**Town of Easton Planning Commission
Draft Decision Summary**

Thursday, June 20, 2024 at 1:00 p.m.

**PLANNING COMMISSION
PUBLIC HEARING
STAFF REPORT**

DATE: June 25, 2024
TO: Brett Ewing - Lane Engineering
cc: Sierra Clem - Town of Easton
FROM: Rick Van Emburgh, P.E. – Town Engineer
SUBJECT: 406 Marvel Court
Sketch Plan & Sketch Stormwater Management Design Review

SHEET No. **2 OF 2** DATE: _____

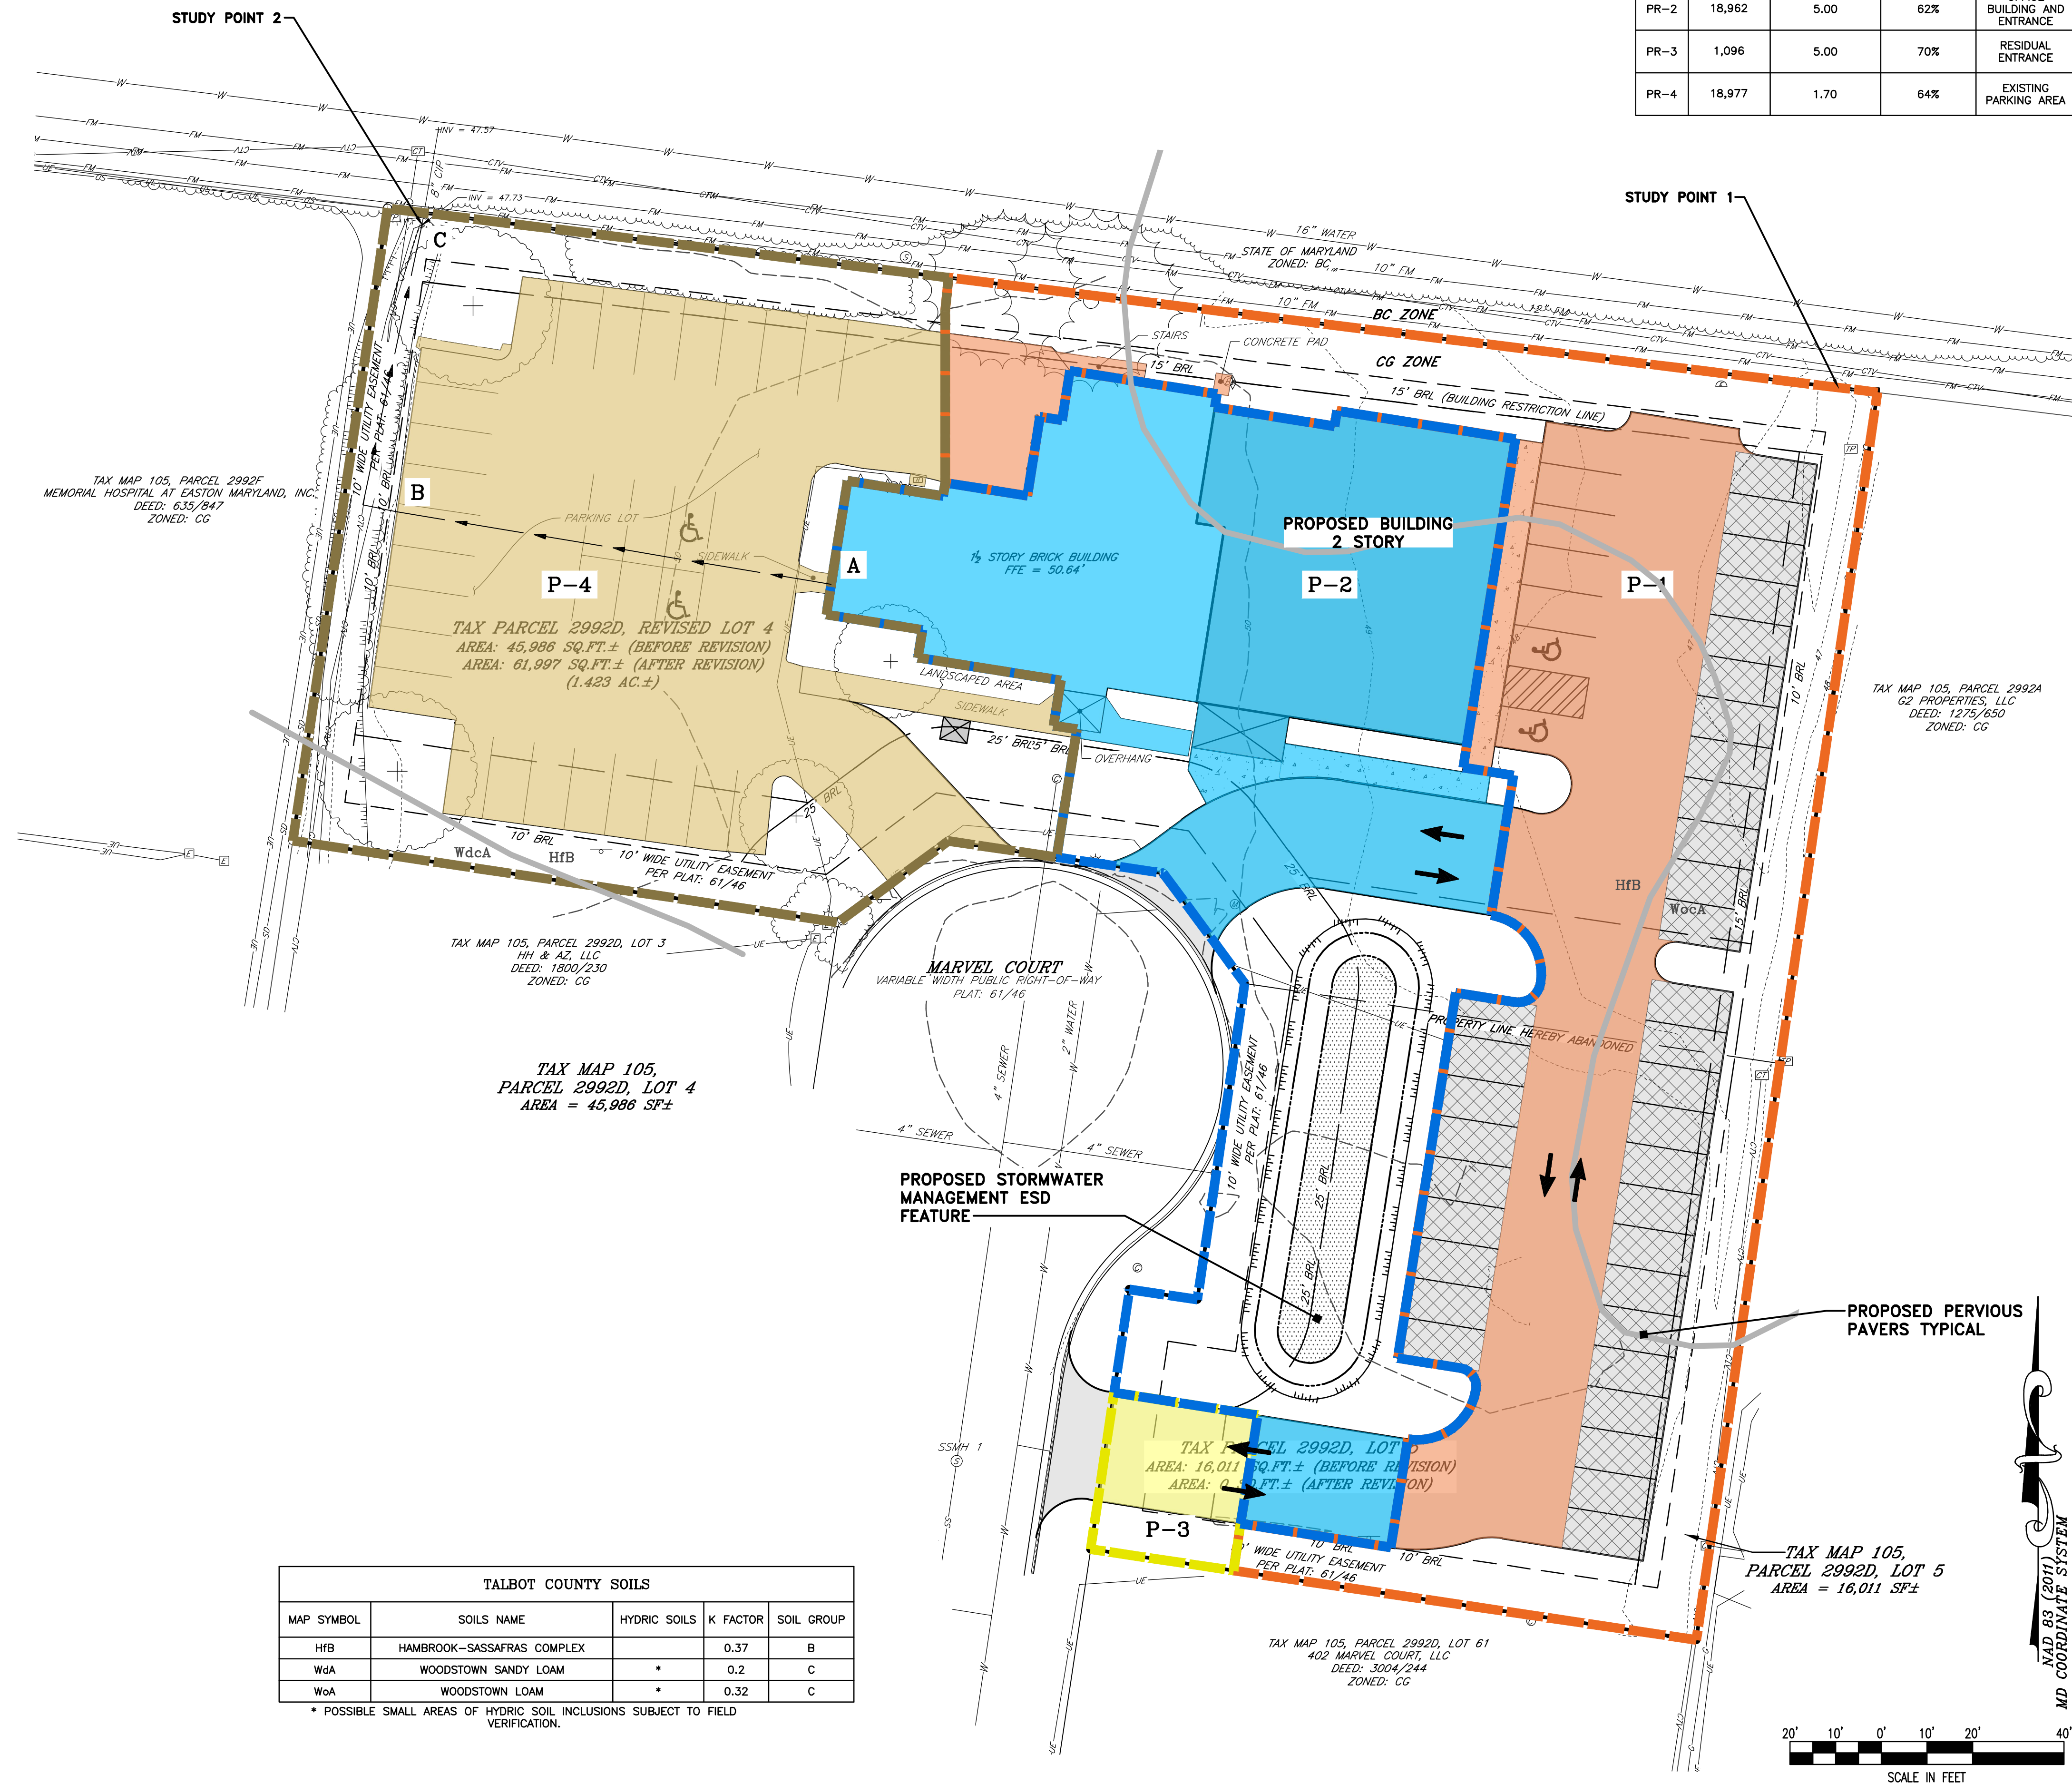
1. Replace the “*Crepe Myrtle*” plant selection with a native plant species.
2. Is there existing landscaping along the east side of the property? If so please indicate on the Sketch Site Plan, sheet 2 of 2.

5. Show zoning district boundaries on the Vicinity Map and add the Ward District within the Title Block.
6. Round up the parking calculations to the highest number.

screening adjacent to Parcels 2992A and 2992D (Lot 61). Elaborate within the *Landscape Requirements Summary Per Ordinance: Section 1014.6 E (Commercial/Office Uses)* on sheet 2 of 2 how the screening requirements have been satisfied. **See attached markup.**

1. **SHEET 2 OF 2** - Provide Sidewalk along all ROW frontage per Town Zoning Code Section 28-1016.
2. **SHEET 2 OF 2** - Proposed entrances should be consistent with TOE-R-4.02. Radii are acceptable, but material should be concrete to ensure ADA compliance.

3. **SHEET 2 OF 2** - Provide Target ESDv values in ESD Summary Chart.

C-501

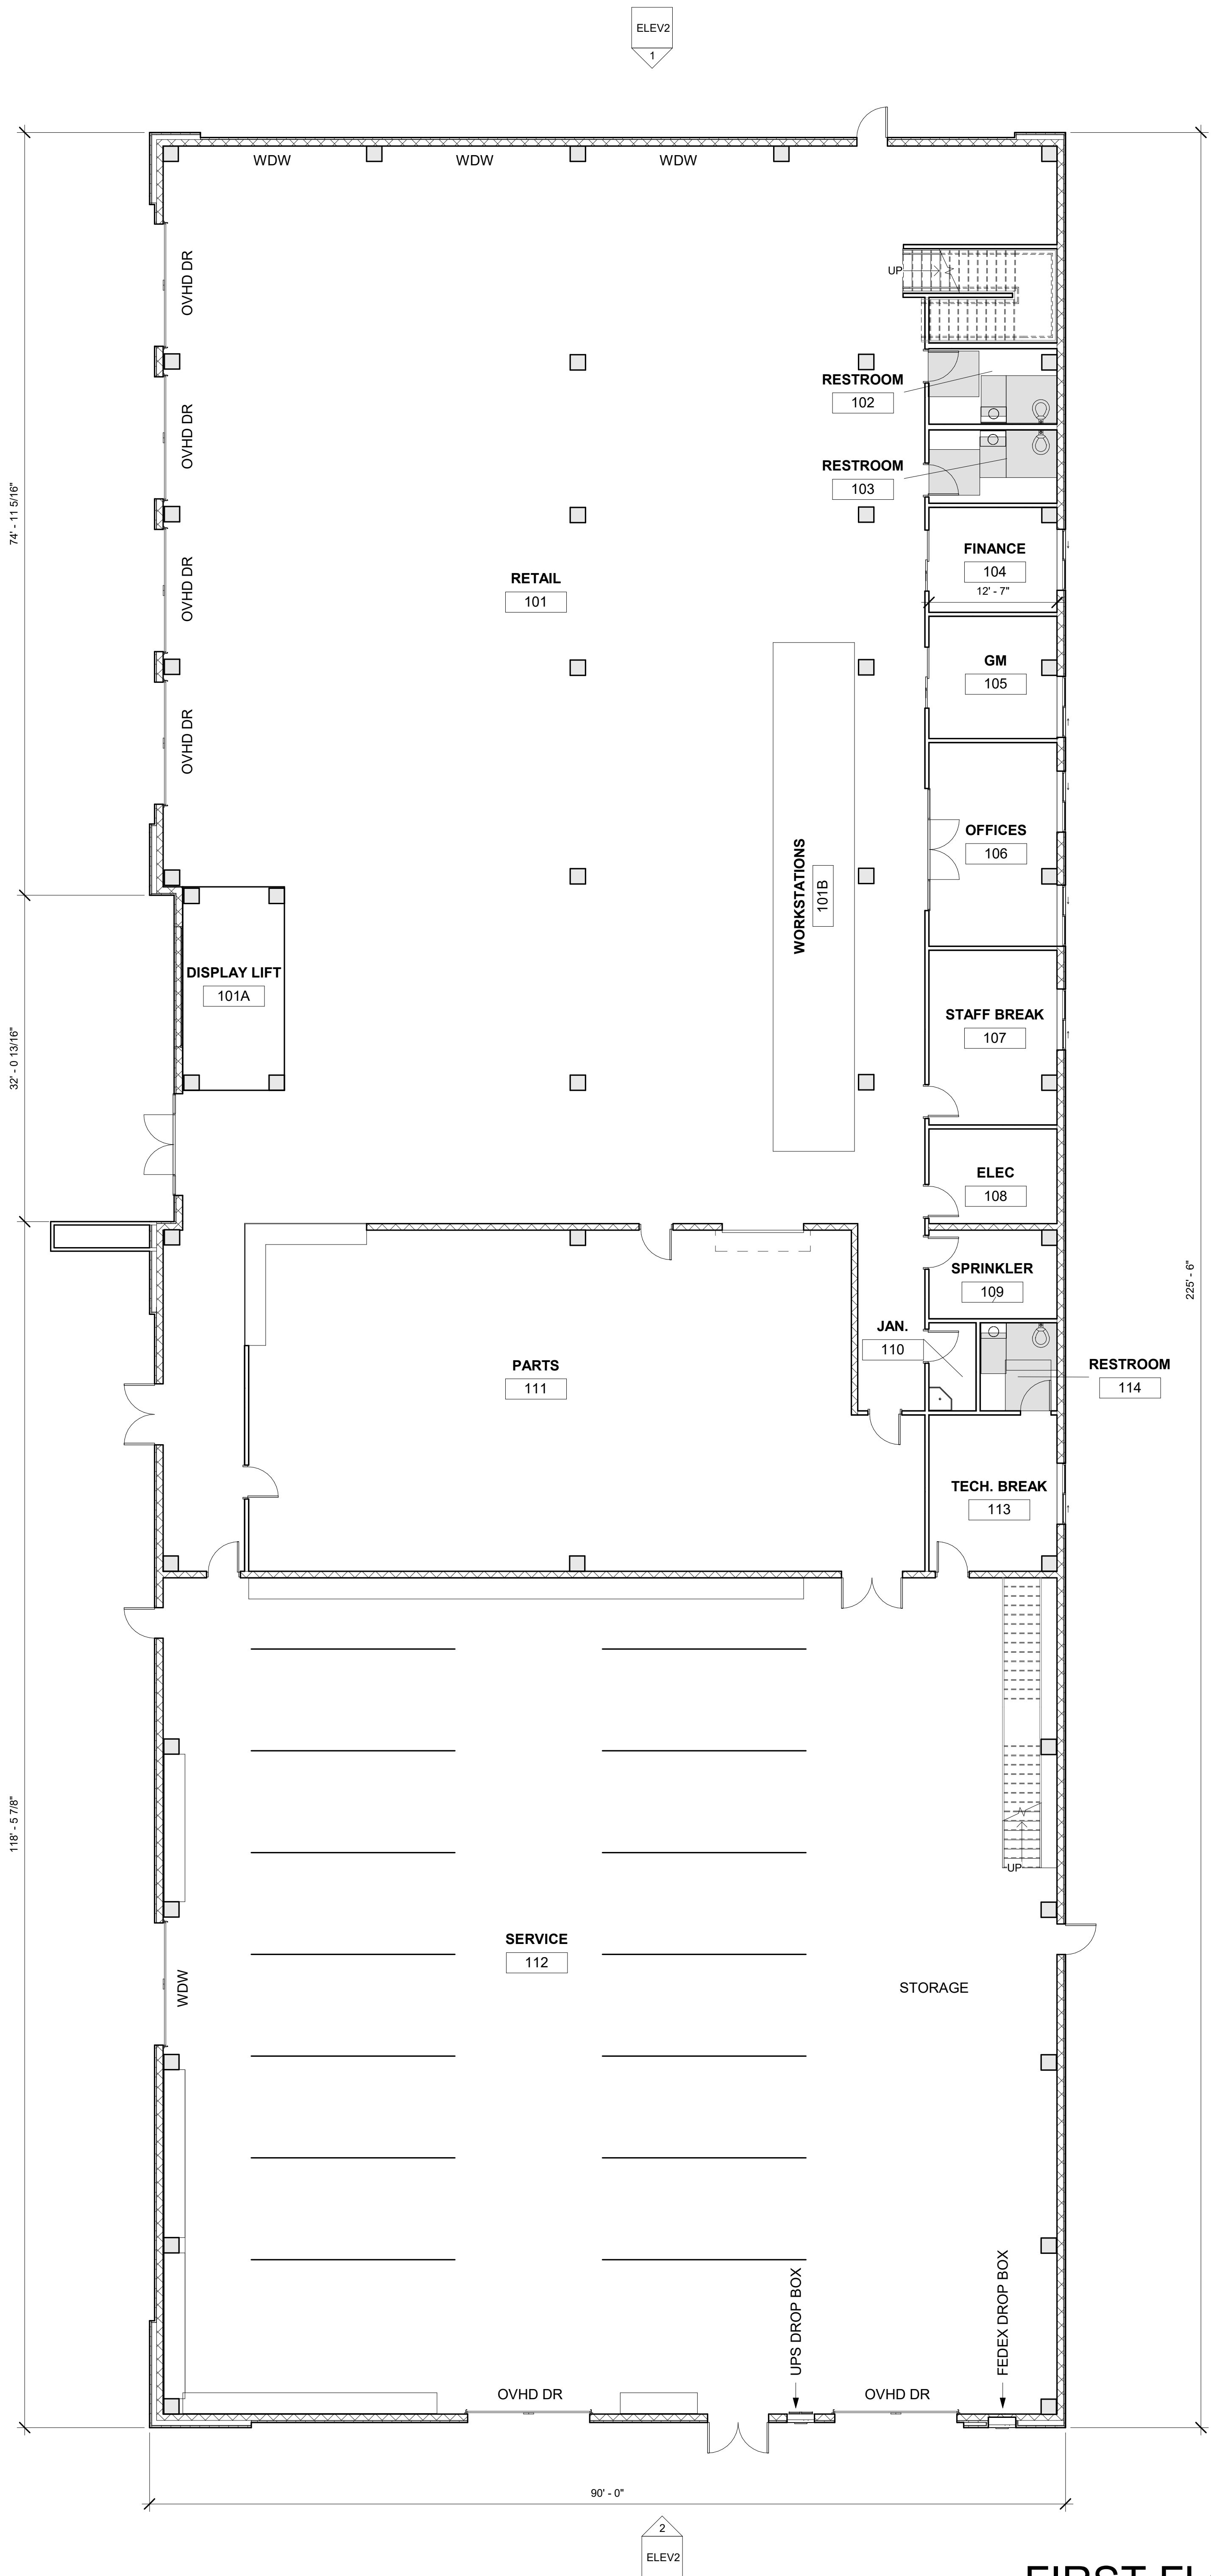
ITEM:	DRAWING /	
	PAGE	COMMENTS:
1	C-501	See electric comments. Previous comments were not addressed
2	General	Gas is available in the area
3	C-100	Fire hydrant shall not be located off of the fire line. Extend watermain along route 50.
4	General	Meter pit shall not be on private property
5	General	Confirm easement for Hyde Park entrance
6	C-203	Crossings not shown on profiles
7	C-501	Submittals required for oil/water separator
